Omaha Public Power District

Director of Nuclear Reactor Regulation
ATTN: Mr. Robert W. Reid, Chief
Operating Reactors Branch No. 4
U. S. Nuclear Regulatory Commission
Washington, D. C. 20555

Reference: Docket No. 50-285

RESPONSES TO THE COMMISSION'S CONCERNS
REGARDING LONG TERM CORE COOLINGQuestion 1

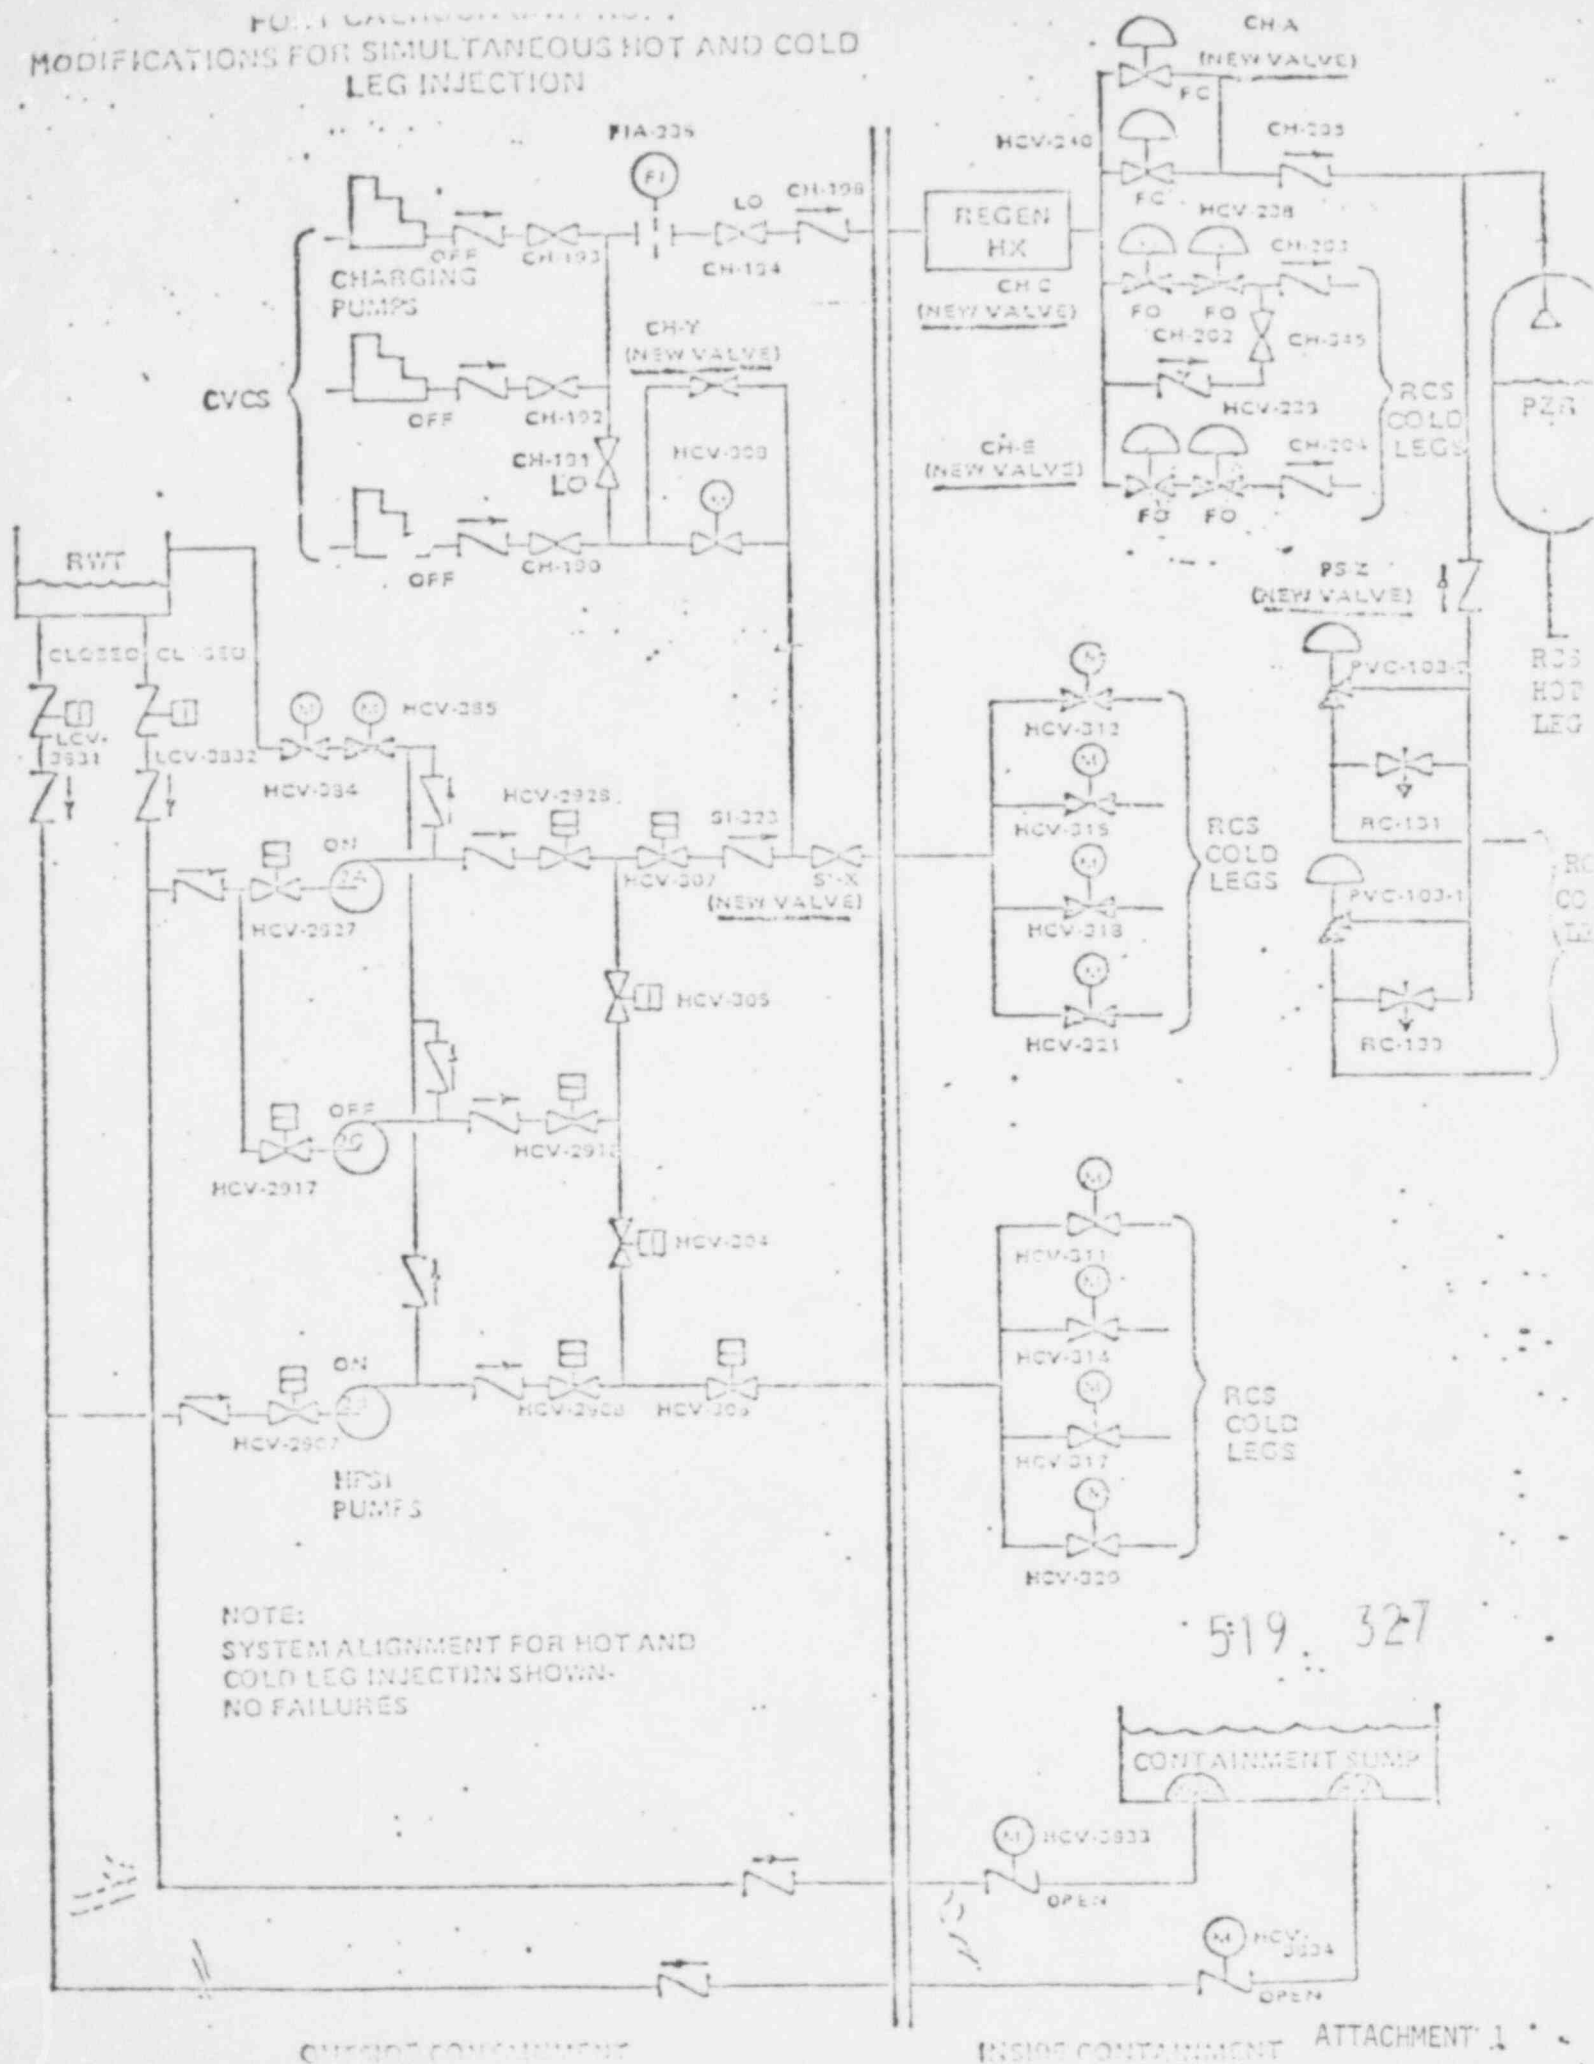
In order to assure adequate flow of water through the core during simultaneous hot and cold leg injection mode, the flow of water to the hot and cold legs should be carefully balanced. This requires the knowledge of the flow path characteristics of the system. In view of the fact that the hot leg flow path is very complicated, involving several different lines and valves, you are requested to provide the following information:

- a. Show that all the lines in the hot leg injection flow path have sufficient capacity for maintaining adequate hot leg injection flow, regardless of the location of the break.
- b. Show that satisfactory procedures and instrumentation exist for monitoring hot leg injection flow.
- c. Explain in detail the procedures used for aligning the flow path for hot leg injection during the long term cooling after a LOCA.

- a. As indicated above, in response to Questions 1, 2, and 3, the hot leg suction method, involving a very complicated hot leg flow path, is not intended for use as a permanent post-LOCA long term cooling procedure. The District, instead, has decided to utilize the pressurizer auxiliary spray line as a means of hot leg injection. This path in conjunction with the cold leg injection paths ensures post-LOCA core flushing regardless of break location.

The proposed system for hot leg injection has been analyzed with regard to the hydraulic performance and system reliability. It has been calculated that the hot leg injection path and cold leg injection paths will each have a flow of 175 gpm. This value is in excess of the requirements during the time of core flushing. Also, modifications will be made to the system in order to enhance the system reliability. A basic sketch of the modified system is provided as Attachment 1.
